Affected : Sailplane model " BS 1 "
- all serial numbers -

Subject : Rudder gimbal drive
- rear actuator arm -

301-45-13

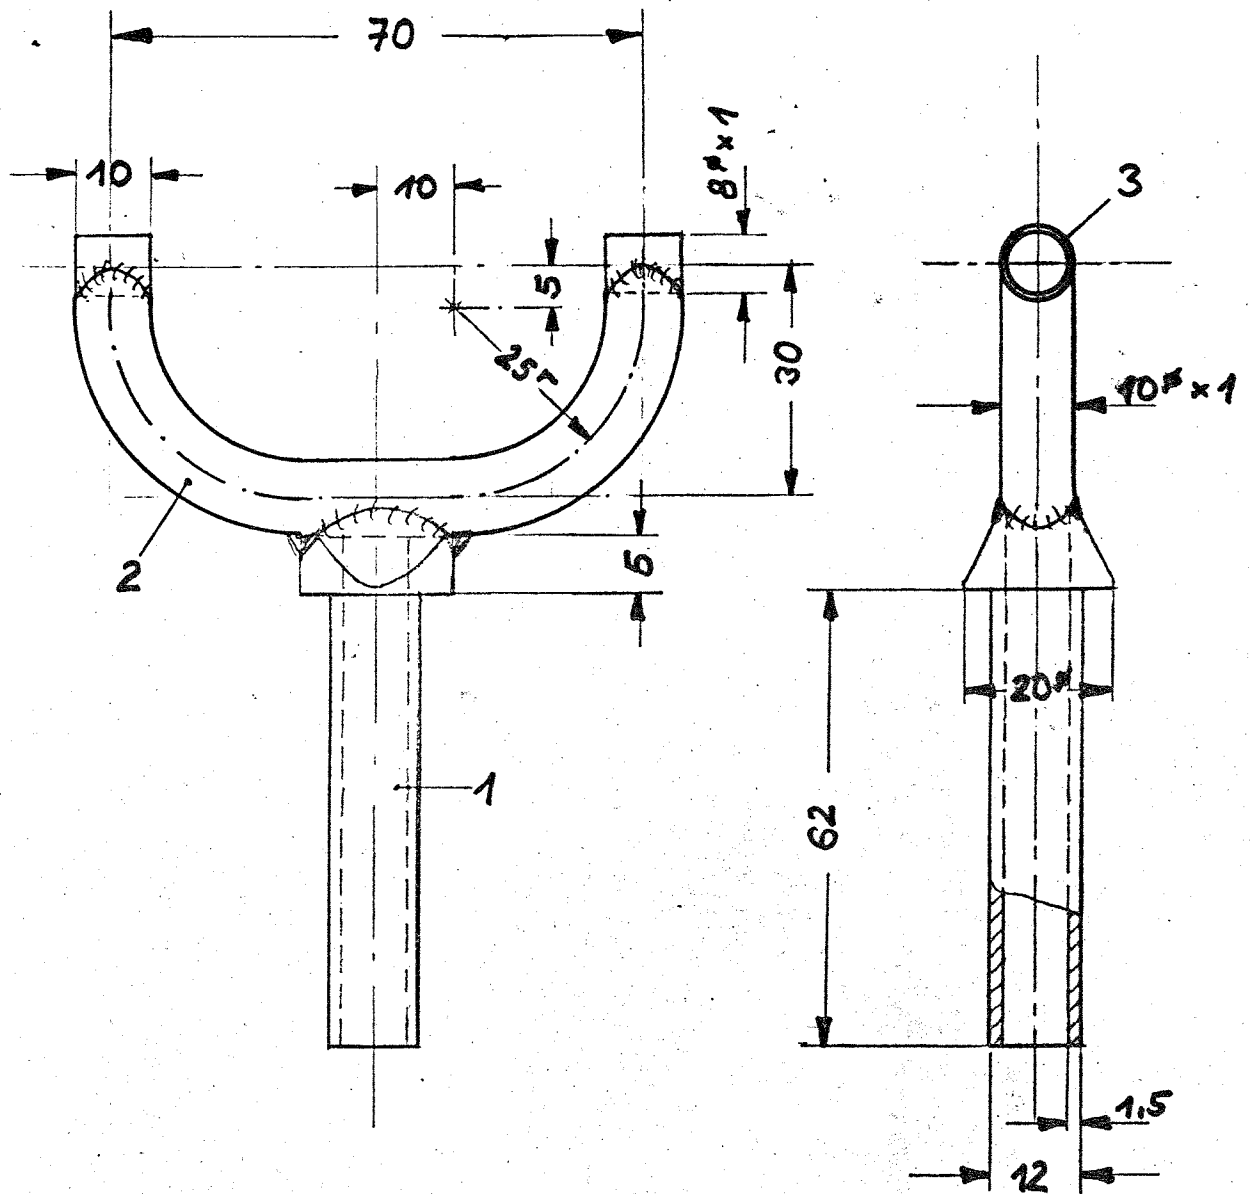
Reason : Failure of the actuator arm caused by loads applied
when regularly lifting the fuselage by its rudder.
and/or when fuselage has broken.

Actions : The faulty part, made according to drawing No. 301-45-10,
must be replaced by an improved actuator arm, made in
accordance with drawing No. 301-45-13.

1. Remove rudder by disconnecting the tail chute, removing the M4 bolt securing the actuator arm to the rudder (located in a cavity at the lower end) and detaching the fairing between the two elevator halves.
2. Remove horizontal axle from gimbal drive by removing the castellated nut.
3. Remove both castellated nuts from rudder actuator arm and pull mounting bolts inwards and off.
4. Attach new actuator arm to gimbal drive by re-inserting mounting bolts. Make sure that bolts are fully home so that bolt heads contact inner face of diagonal bushings - also take care that the actuator arm shows no axial play when seated on these bolts, then only tighten castellated nuts lightly and secure with split pin.

5. Re-attach rudder gimbal drive to its mount on the lower end of the fin by inserting the horizontal axle with its spacers. Tighten castellated nuts lightly and secure with split pin. Again, make sure that, with the assembly completed, there is no axial play, if so, proper shims must be used to eliminate the play.

6. Re-attach rudder and tape it to fin when in proper position to avoid any aft movement.
7. Slide flange bushing onto actuator arm and secure in position by a wedge placed between bushing and cavity wall. Make sure that the bushing's 4 mm holes are horizontal.

Punch mark actuator arm on both sides at the center of the bushing's 4.0 mm holes and drill arm to a diameter of 2.0 mm. With these holes properly aligned, drill to a diameter of 3.8 mm, then ream to 4.0 mm. If the 2.0 mm holes are not aligned, it is possible to use a round needle file for centering, then drill and ream to proper diameter.

8. Insert locking bolt and secure with M4 stop nut.
